HYUNDAI Technical Service Bulletin	GROUP BODY ELECTRICAL	NUMBER 19-BE-016H
	DATE OCTOBER 2019	MODEL(S) ELANTRA (ADa)
SUBJECT: BLIND-SPOT RADAR REPLACEMENT, AND MOUNTING ANGLE VALIDATION

This bulletin provides the service procedure to replace the left and right Blind-Spot radar modules.

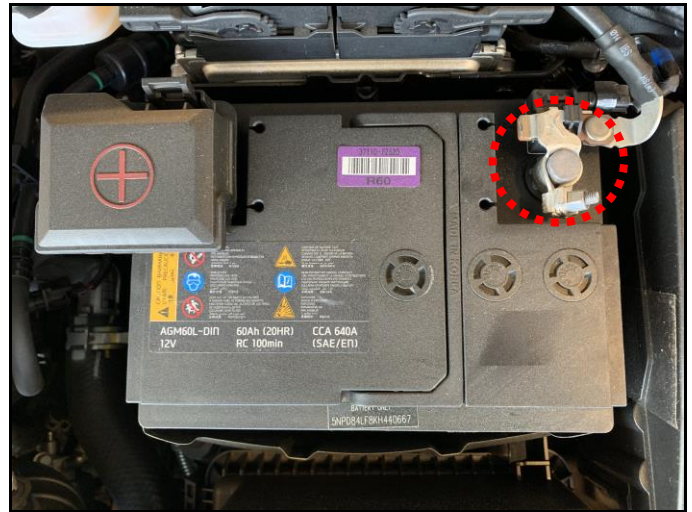
8. Install the new LH and RH Blind-Spot radars assembly in reverse order of removal.

Tightening torque:

Radar bracket :

3.9 - 5.9 N.m (0.4 - 0.6 kg cm, 2.9 - 4.4 lb-ft)

Radar unit :

3.92 ± 0.98 N.m (2.9 lb-ft)

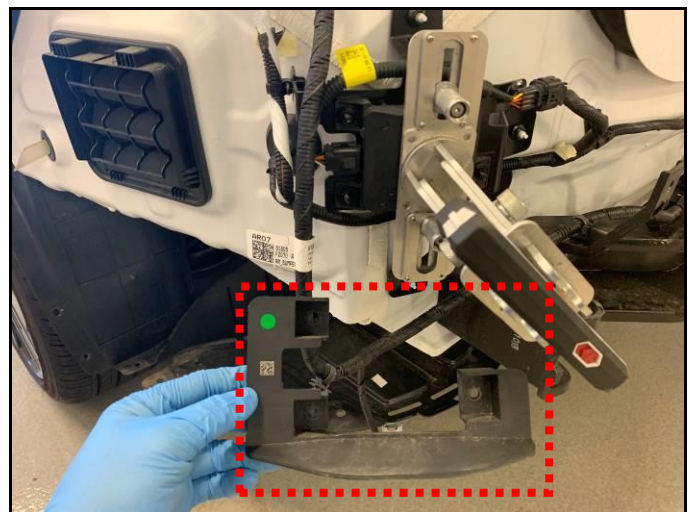
LH and RH Blind-Spot Radar Mounting Angle Specification:

Horizontal Angle: 55° ± 3°

Vertical Angle : 90° ± 1.5°

The Blind-Spot radar plastic shield must be removed, otherwise the laser clamp will not be able to clamp onto the radar.

Remove the 8mm mounting nuts to remove the radar plastic shield.

After measuring the mounting angles, ensure the plastic shield is reinstalled back onto the radar module.

If the Blind-Spot radar is not within specification, then use washer(s) to shim the Blind-Spot radar bracket(s) to adjust the mounting angles.
